# **PRODUCT CAMPAIGN BULLETIN**

**SUBJECT:** PCV Valve- Design Change

**NUMBER:** WUW-08R

**NHTSA ID:** 19V-856

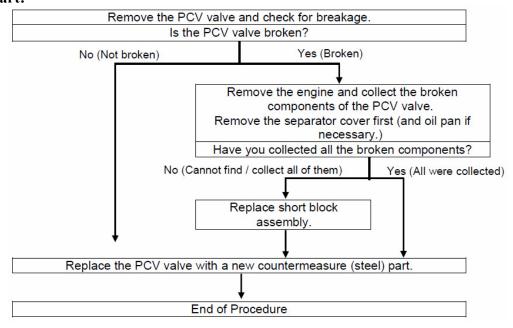
Replace the PCV Valve using p.n. **11810AA230**. Reinstall the original PCV hose.

**IMPORTANT NOTE:** p.n. **11810AA230** is currently on hold status. Retailers MUST contact the Parts PIC team and provide a valid VIN. The part can then be released once the impacted VIN is verified.
